Independent spatial data analyses of the 2019 Chickahominy Power Plant, Charles City County, Virginia, for environmental justice, indigenous tribal lands and Significant Impact Levels (SILs) of modeled project emissions.

Project & Analyses Introduction:

GE - 1 Hour NO2 SIL

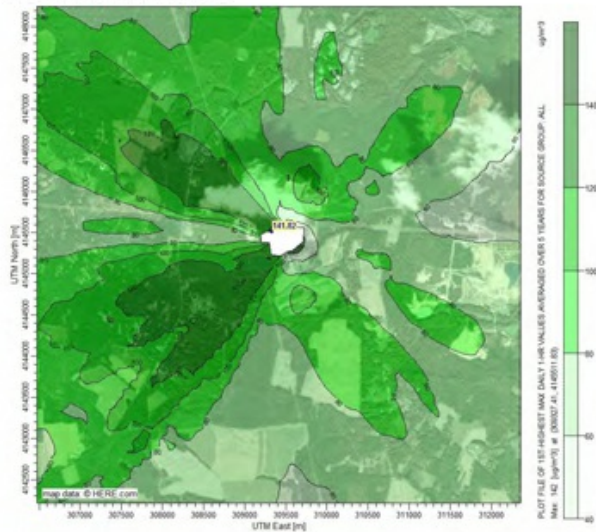
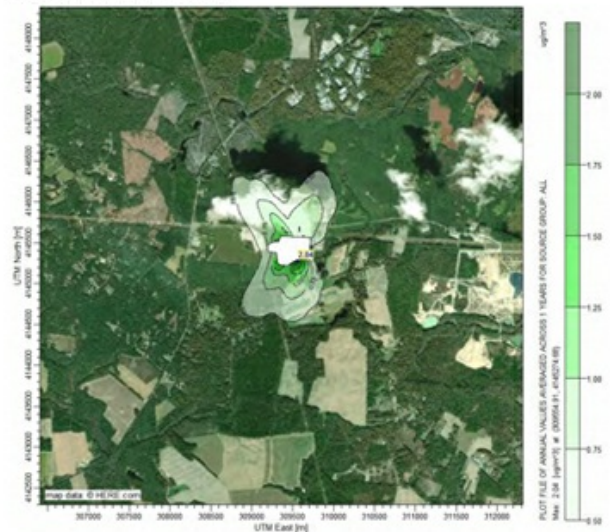
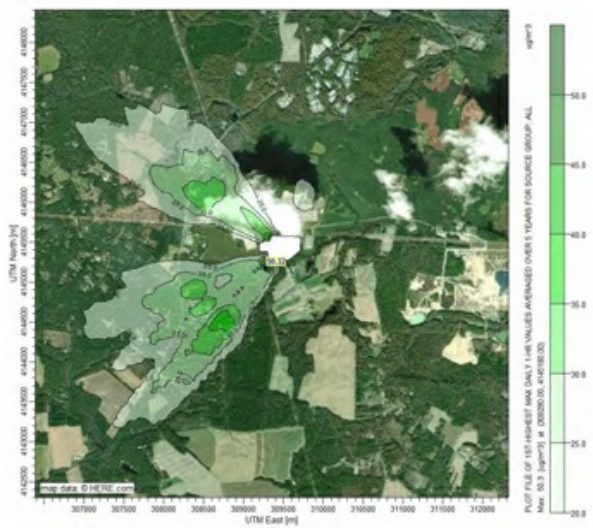
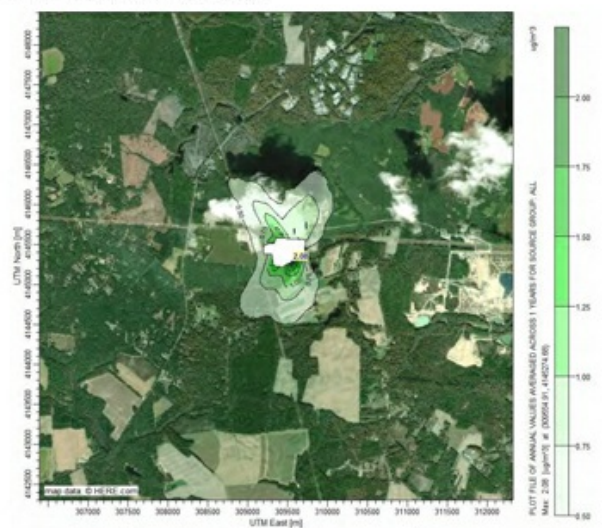
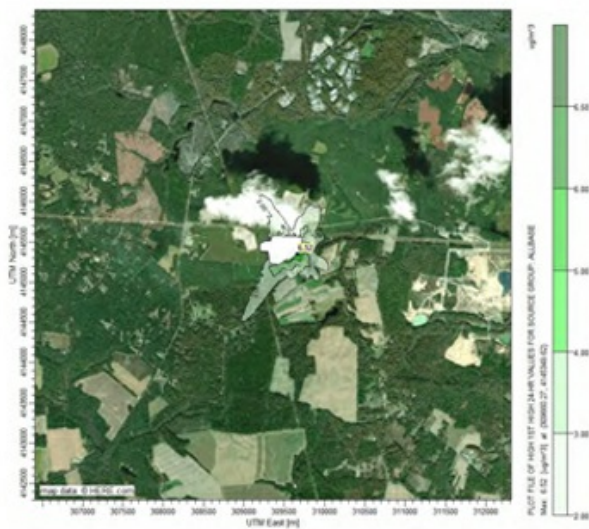
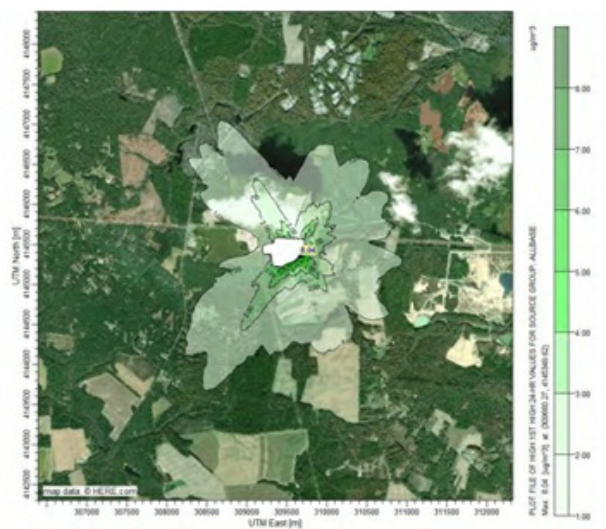
The resulting isopleths for each SILs concentration are shown on page 14 for both turbine combinations (extracted from *Appendix G - Air Quality Impacts - Contour Map*). It is clear from these cartographic outputs that concentrations will emanate outwards to the C4GT facility and across terrain shared by the C4GT facility; but like the larger report, these maps are quiet on the issue of both the extreme proximity and combined spatial distribution and concentration of both emission source points across all modeling scenarios. Further, while the application alludes to an *Appendix F* where background concentration sources would be listed, the currently posting shows *Appendix F* as a blank page.

VDEQ recently proposed a permit for another gas-fired combined cycle power plant, the C4GT Charles City Combined Cycle Power Plant, which is planned to be located within a mile of Chickahominy. Given the proximity of these sources, it is imperative that the Charles City Power Plant's emissions be included in the cumulative modeling done for Chickahominy.

Clearly, the cumulative modeling for Chickahominy understated emissions from the C4GT combustion turbine generators and thus the cumulative NO2 analysis is significantly flawed, especially given how close these plants will be to each other.

...the cumulative NO2 NAAQS analysis is significantly flawed due to the failure to adequately model allowable short-term average NOX emissions from the nearby C4GT plant and the failure to model concurrent worst case NOX emissions from both the C4GT plant and Chickahominy.

The use of a proper background 1-hour NO₂ concentration is extremely important given how close the modeling of the Chickahominy plant when equipped with GE 7HA.02 turbines is to the 1-hour NO₂ NAAQS. Chickahominy Power reported a modeled concentration of 1-hour NO₂ of the plant with GE 7HGA.02 turbines of 180.23 µg/m³, which is almost 96% of the 1-hour NO₂ NAAQS of 188 µg/m³.⁸⁴

The proposed Chickahominy and C4GT facilities would be sited within one mile of each other, creating further potential for a localized pollution hotspot.
